ACCESSION NBR: 8408280001 DUC DATE: 84/08/24 NOTARIZED: YES DOCKET #  
 FACIL: 50-410 Nine Mile Point Nuclear Station, Unit 2, Niagara Moh 05000410  
 AUTH. NAME AUTHOR AFFILIATION  
 MANGAN, C.V. Niagara Mohawk Power Corp.  
 RECIP. NAME RECIPIENT AFFILIATION  
 SCHWENCER, A. Licensing Branch 2

SUBJECT: Forwards responses to listed SER open items. Info will be included in next FSAR amend.

Re: Nine Mile Point Unit 2  
Docket No. 50-410

FIGURE 13.1-7

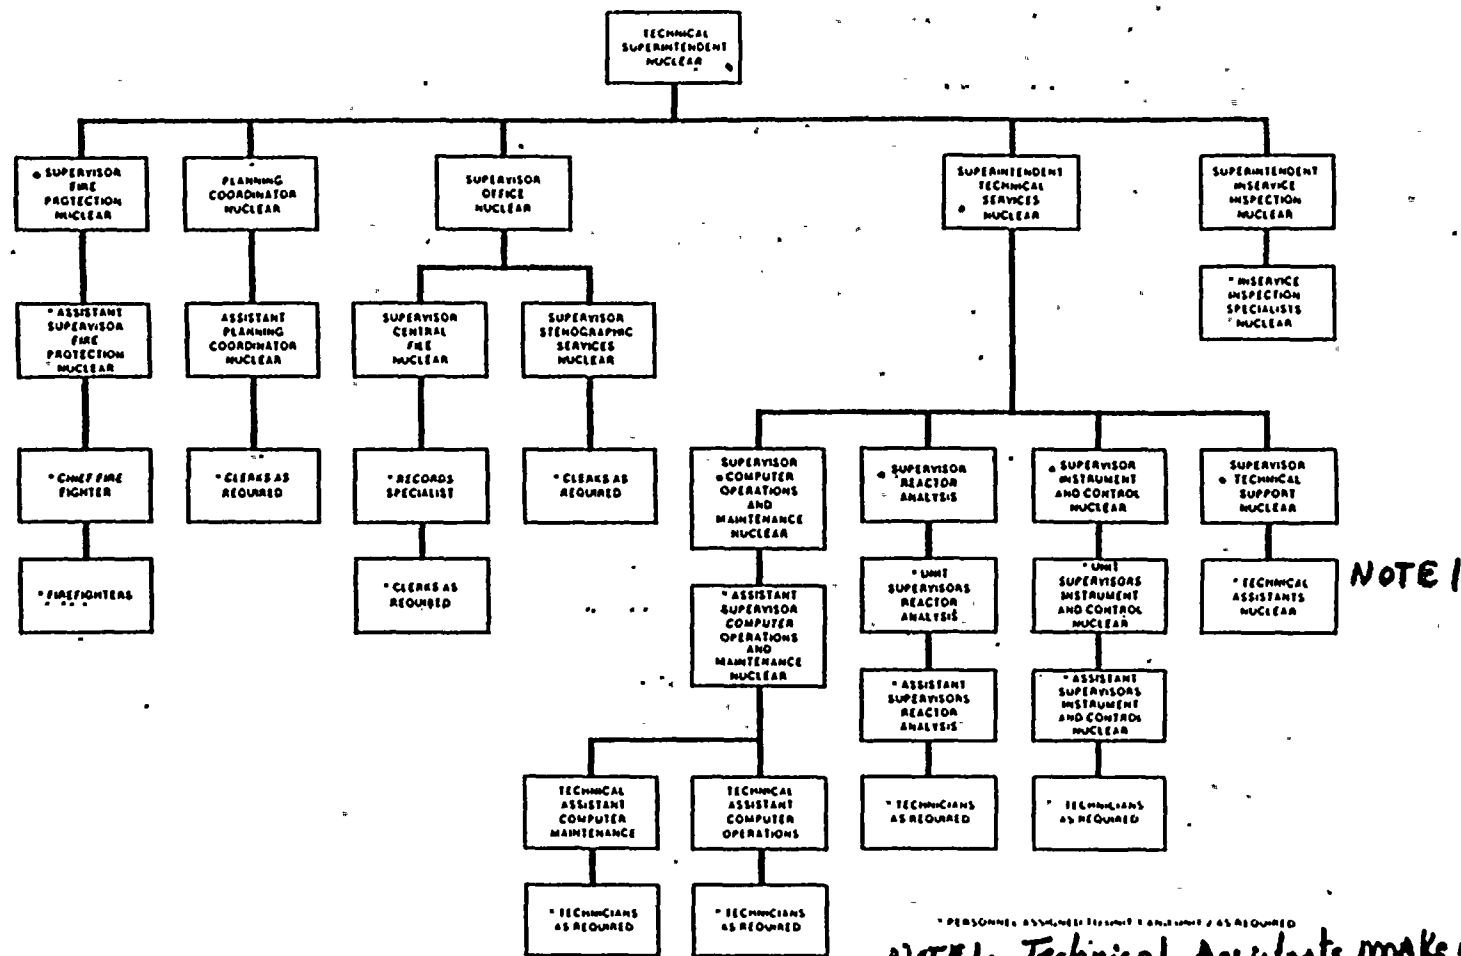
- (a) Figure 13.1-9 shows that the health physics and chemistry functions at NMP-2 are not separated into a Health Physics Section and Chemistry Section supervised by a Health Physics Supervisor and a Chemistry Supervisor as recommended by our positions in Section II.A.1 of NUREG-0731. The organization and Figure 13.1-9 should be revised to reflect separate supervision of these distinct functional areas..

See revised Chapter 13.
